RE: Progress report for October 2005 activities - Hecla Mining Company Apex Site (EPA ID No. UT982589848, Docket No. RCRA-8-99-06)

SUBJECT: **Progress Report No. 18 for period ending October 31, 2005; Pond 2 Final Closure - Apex Site, Washington County, Utah**

TO: Chris Gypton (Hecla Mining Company)
FROM: Doug Gibbs (Monster Engineering Inc.)
DATE: 11/2/05
SUBJECT: **October Site Visit and Construction Review - Apex Site**

Monster Engineering Inc. Observations and Suggestions Provided to Gila Management

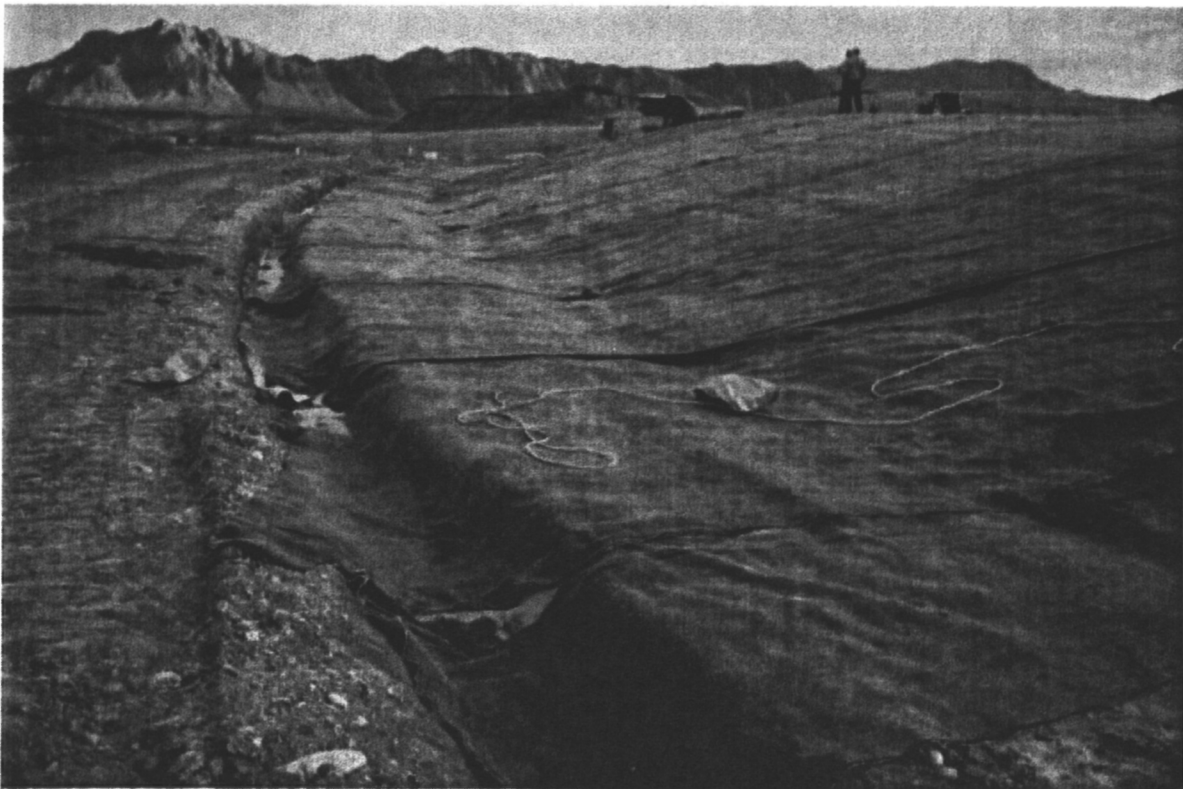
MEI's Suggested Priority	Area / Material	Observation / Suggestion
1	GCL Deployment	CETCO's "Supergroove" seam sealing technique approved. Use additional bentonite at end of panels and at all "cut to fit" panels. No seams allowed perpendicular to 3.5:1 slope. Panel Deployment Plan provided by contractor is approved.
2	GCL QA / QC	Most important areas for observation and QA are at, and within 3 vertical feet, of the seam between the old liner and new GCL liners. Watch for and do not allow folds in GCL, especially at seam locations. Examine all seams for either Supergroove sufficient granular bentonite. Inspect all panels for correct layering (i.e. shingling). No soil allowed in overlap / seam areas. No deployment allowed in standing water / liquid. How to patch damaged GCL areas reviewed and discussed.
3	Surveying / QA	More surveying is required to verify slopes, trench locations, material thicknesses including, and allow for accurate post construction documentation of work completed according to plan. Surveying should include but may not be limited to: <ol style="list-style-type: none"> 1) Outslopes – pre-GCL placement (what is current slope?) (collect data at top, mid-slope, and bottom at 50' intervals minimum). If GCL is already covered then holes must be hand dug back down to GCL to allow for soil cover thickness measurement and survey shots on GCL at those locations. 2) Outslopes – post cover soil placement (collect data at same locations as above) 3) Outslopes – post rock (same locations as above) 4) Anchor trenches – top and bottom at lip (50' minimum) 5) Slope break (1% to 3.5:1) – post GCL placement 6) Slope break (1% to 3.5:1) – post cover soil placement 7) Pond top – to verify Contractor's work (or to provide feedback on where they need to cut and fill to achieve 1% - 50' grid suggested) 8) Pond top – after 1% achieved, either pre or post GCL placement (50' grid suggested) – provides baseline for later survey / verification of 1' of cover soil 9) Pond top – post cover soil placement (1' of cover verification) 10) Erosion protection trench (to verify correct depth and slope) 11) Erosion protection rock (to verify placed thickness prior to backfilling) <p>Set up standard survey schedule (suggest every 3 to 5 work days). Don't let slope break location "drift" as cover soil is placed. Use feedback from 10/26/05 survey to make sure contractor balances current waste material within the pond to create the required 1% top slope. Don't import additional clean borrow from borrow area as we may run out of borrow for GCL cover and then have to pay contractor to haul in additional borrow.</p>

4	GCL Cover Soil	<p>Verify that contractor maintains minimum 1' cover at all times.</p> <p>Don't allow excess "pushing" by dozer.</p> <p>Place 2' of cover only in high traffic areas.</p> <p>Don't allow sudden stops and starts by equipment on cover soil.</p> <p>Don't allow contractor to place excess (>1') in all areas as borrow materials are limited.</p> <p>Verify soil cover material thicknesses with hand-dug holes in areas where surveying QA has not been collected on GCL elevations (NW, N, NE, E sides of pond).</p>
5	Subgrade	<p>Currently too soft for GCL deployment on top in limited areas.</p> <p>These areas require additional drying and compaction.</p> <p>Subgrade to be tested and verified prior to GCL deployment, especially in current "wet" areas.</p> <p>Subgrade must be approved by contractor ("Rainy Day").</p> <p>Oversized must be hand picked and voids must be filled prior to GCL deployment.</p>

6	Excess Liquids	<p>Contractor should move discharge hose constantly and spread liquid to speed up evaporation.</p> <p>Don't allow liquid to "pond" on top.</p>
7	GCL Storage / Protection	<p>Some rolls in storage area not covered (original packaging torn)</p> <p>Some rolls in storage area damaged (potentially during transport).</p> <p>Some rolls stored incorrectly (bent rolls).</p>
8	Borrow Area	<p>Stay in high quality cover soils area (very little rock) as there is a supply of this material.</p> <p>We don't want to have to go off-site for cover soils (too expensive).</p> <p>If rocky materials are encountered don't use as GCL cover.</p> <p>Contractor to re-grade borrow area at end of project to complete diversion channel configuration.</p>
9	Anchor Trenches	<p>Approved by Hecla.</p> <p>Remove oversize prior to GCL deployment.</p> <p>GCL must go through bottom of trench.</p> <p>Remove angular materials at trench corners (at the upper lip).</p> <p>Change distance from bottom trench to top trench to less than 50' (GCL rolls are 150' in length).</p>

10	Erosion Protection	<p>Hecla approved larger rock to replace D50 = 1".</p> <p>Rock materials on-site do not pass the D50 = 3" specification (too uniform in size).</p> <p>Current on-site rock needs more +3" or more -1.5" material.</p> <p>Contractor should not ship more to the site until it passes spec.</p> <p>Preferable to test (and pass) gradation of any and all rock prior to shipment to site.</p>
11	Contractor	<p>Contractor will have difficult time both staying in front of and covering up after "Rainy Day" has placed GCL.</p> <p>Blade not holding up.</p> <p>If it breaks down, work will slow or stop.</p>
12	Rain Protection	<p>AI will discuss rain protection for Friday (10/28/05) with Contractor.</p> <p>Don't allow storm runoff to reach and hydrate currently deployed GCL on sideslopes.</p>

13	Cut & Fill Work on Top Slope	<p>Al will talk with Contractor to make sure they get the top cut / filled and re-bladed to a 1% slope using only the current waste materials and not importing additional borrow.</p> <p>To create balance cut & fill:</p> <ol style="list-style-type: none">1) East side requires up to maximum of 1.3' fill (average of about 0.6' fill over 2 acres).2) West side requires average cut of approximately 0.4'.3) Current elevation of pond center will have to be reduced by approximately 0.4' to 0.6' in order to balance materials.
14	GCL Material Verification	<p>Al to collect bills of lading, individual roll tags and verify that correct materials have been shipped to the site.</p> <p>Al does not appear to have sufficient time to record individual rolls and their deployment locations.</p> <p>Jeff will collect all paperwork, QA/ QC from CETCO concerning materials shipped to the site, and will verify with Al's site information.</p>
